REQUEST FOR PROPOSAL

STATE ENVIRONMENTAL IMPROVEMENT AND ENERGY RESOURCES AUTHORITY (EIERA)

July 15, 2025
Amended August 11, 2025

Waste Management Program August 11, 2025 Amendments to Request for Proposal

Appendix C. Nested Gas Monitoring Probe Detail.

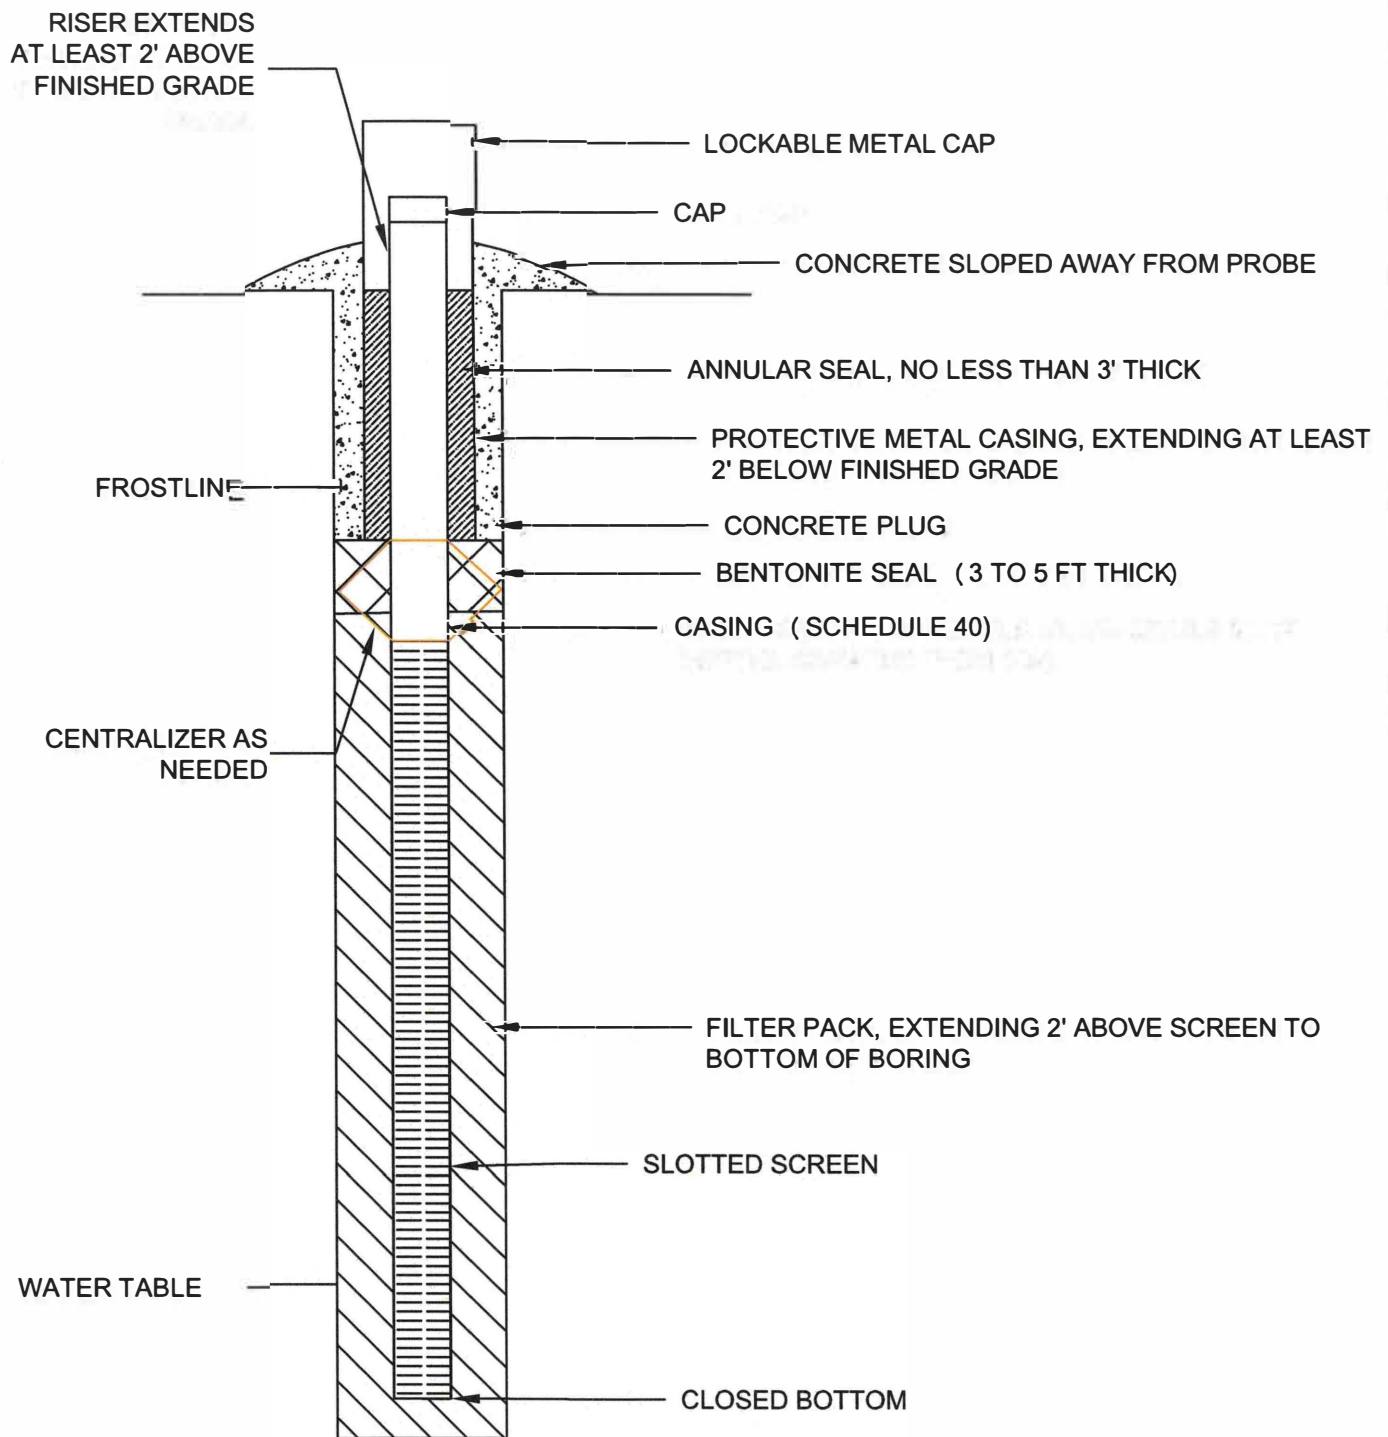
- 2) The original RFP required gas monitoring probes to be installed/constructed as nested probes. A consulting firm asked if the probes could be individually installed instead of installed as nested probes. After review and discussion, the WMP decided to allow either nested or individually-installed and constructed gas monitoring probes. The RFP was amended throughout the document to allow either nested probe or individual probe installation and construction and added a minimum distance between boreholes.

Bidders have the option to propose and bid upon this project whether installing and constructing four gas monitoring probes at each chosen location as nested probes (using two larger boreholes) or as four individual gas monitoring probes (using four smaller boreholes). Bids will be reviewed and compared whether the consulting firm submits a bid for either nested or individual probe installation/ construction (1 bid) or for both the nested installation/construction and individual installation/construction (2 bids).
